Re: Western Clay Bentonite Pits Sevier County M/S/041/012

## Application for Mineral Mine Plan Revision or Amendment

Operator: <u>Western Clay Company</u>	
Mine Name: <u>Redmond Bentonite Pit</u>	File Number: <u>M/5/041 /012</u>

# North Slope

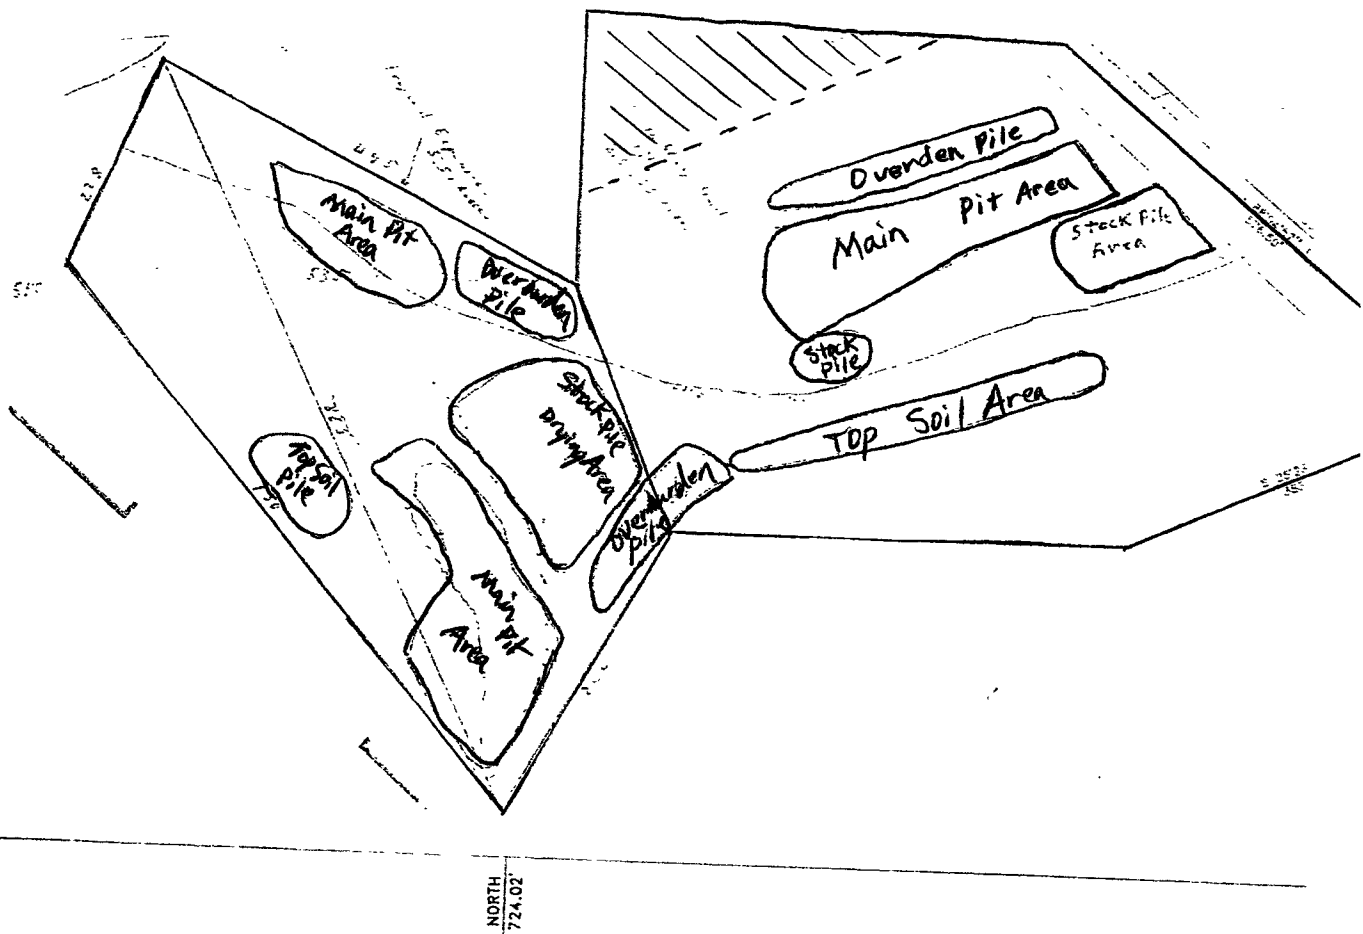
6.42 Acres Original Area

2.34 Proposed Expansion

.73 Will Remain Undisturbed

S0. SHEEP TRAIL FLAT  
5/10/06

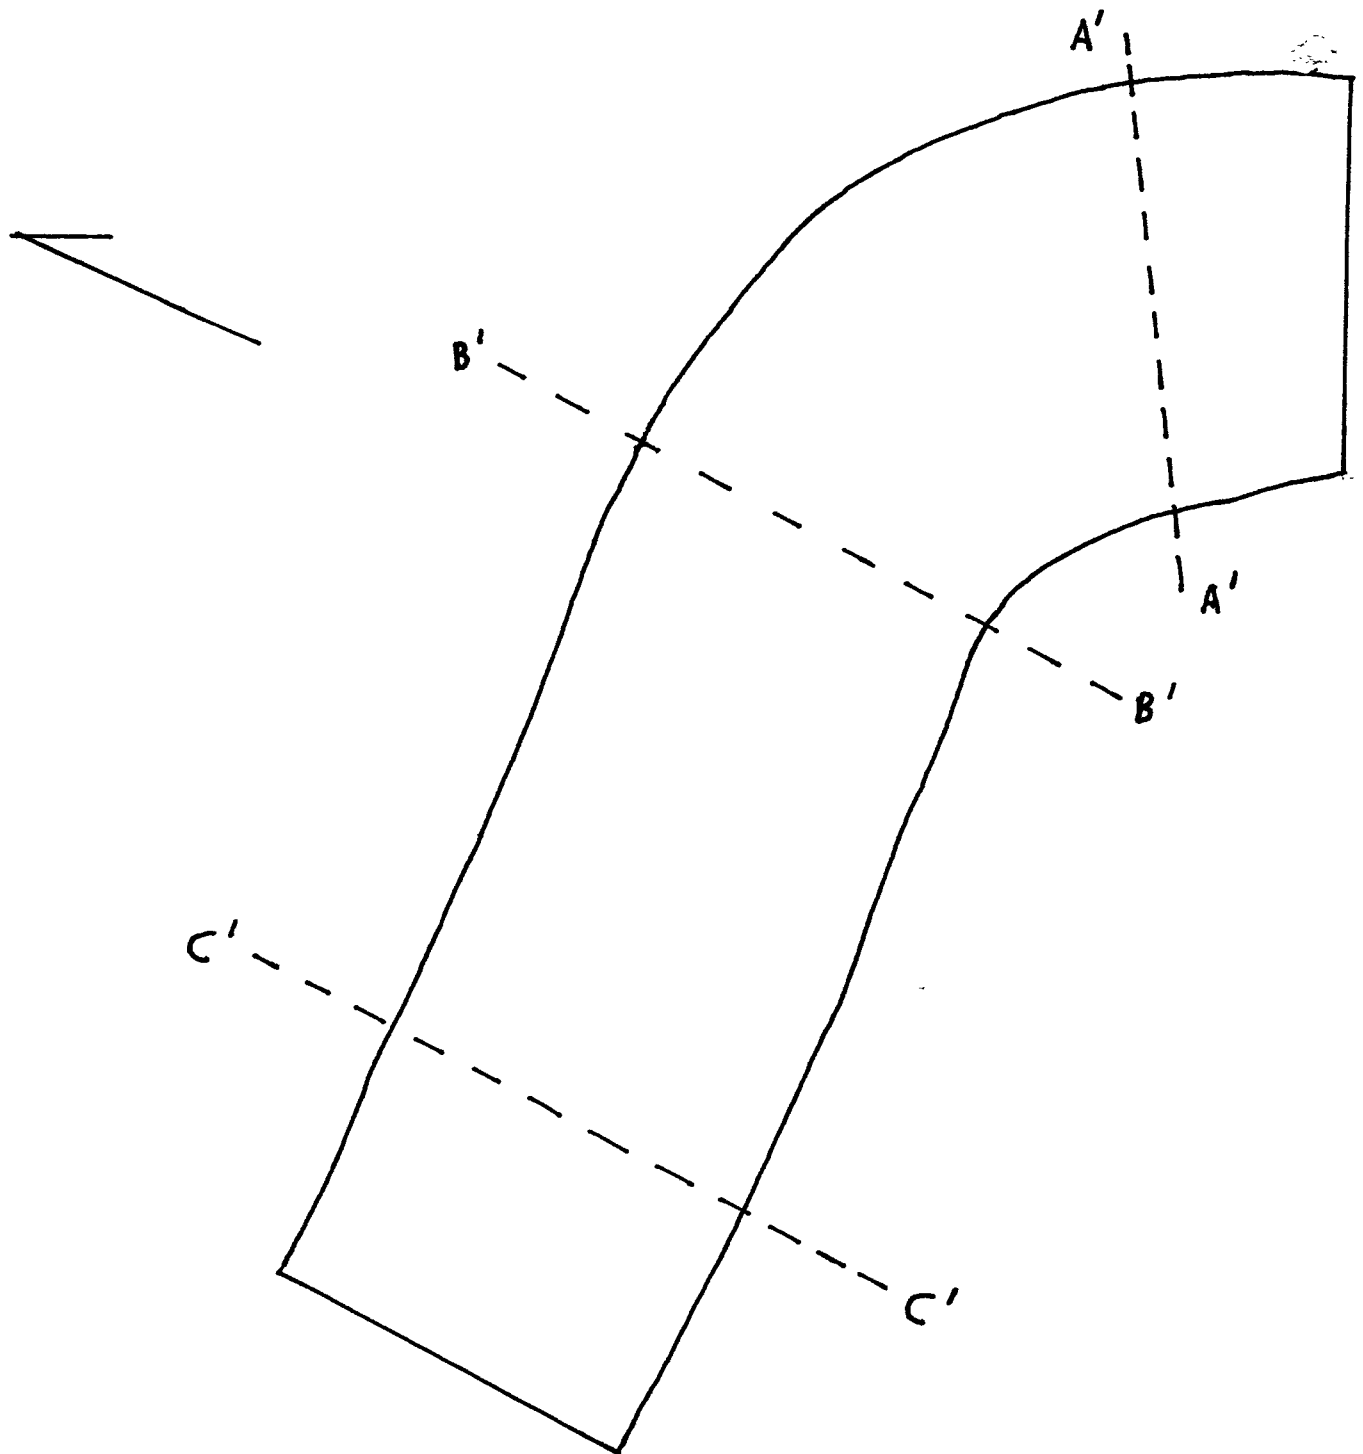
CURRENT MINE AREA NONE  
PROPOSED MINE AREA \_\_\_\_\_  
CROSS SECTIONS - - - - -

5/10/06  
NORTH SLOPE MINE

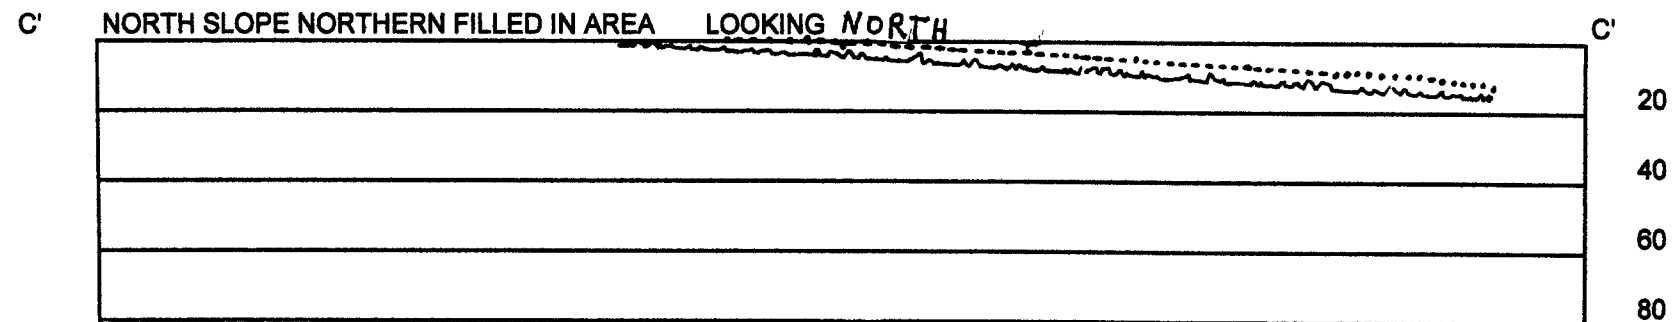
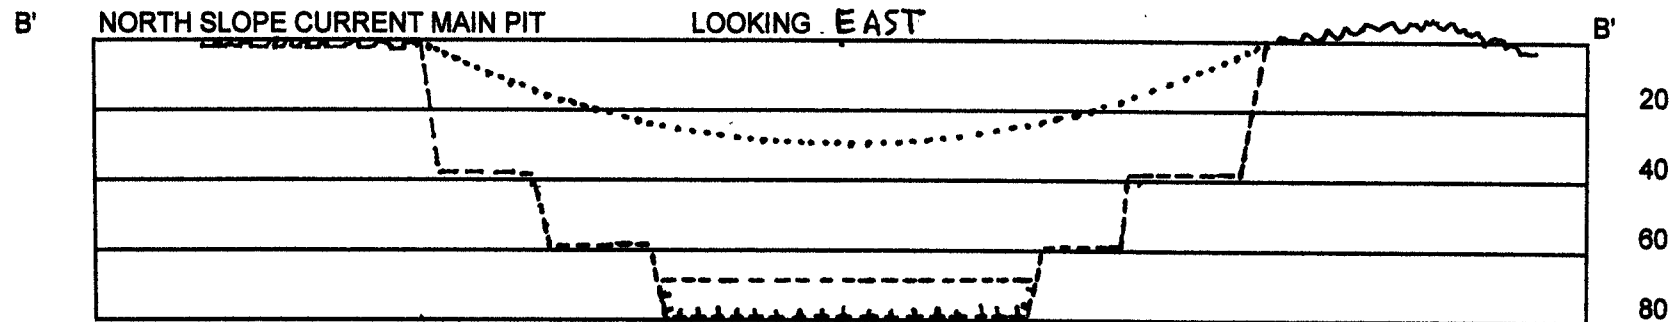
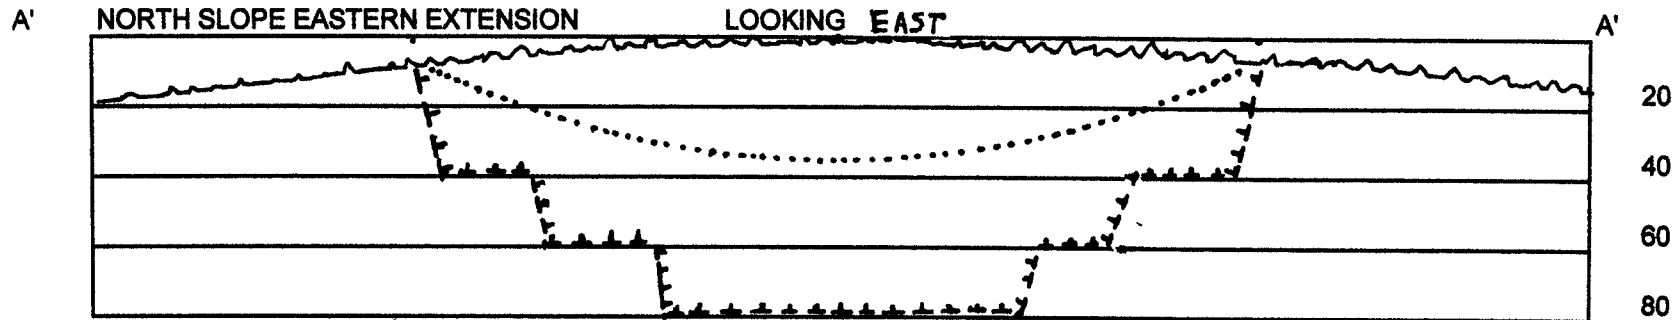
CURRENT MINE PROFILE - - - - -  
PROPOSED MINE PROFILE ▲ ▲ ▲ ▲ ▲  
PROPOSED RECLAMATION .....  
NATURAL CONTOUR ~~~~~

NORTH SLOPE  
5/10/06

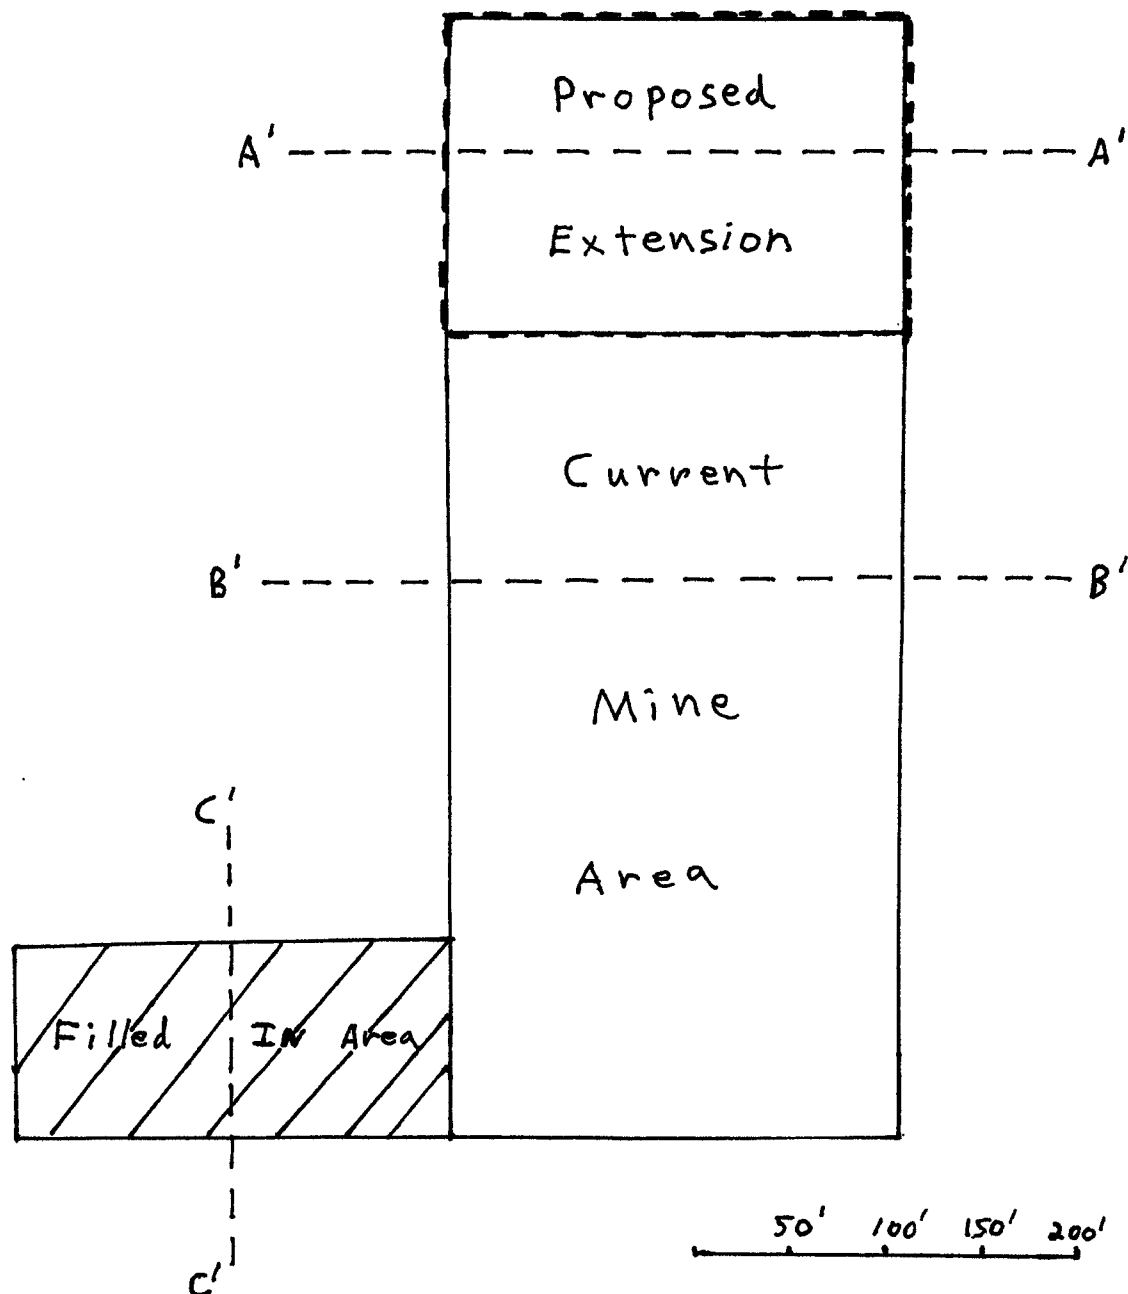
CURRENT MINE AREA      
PROPOSED MINE AREA      
CROSS SECTIONS
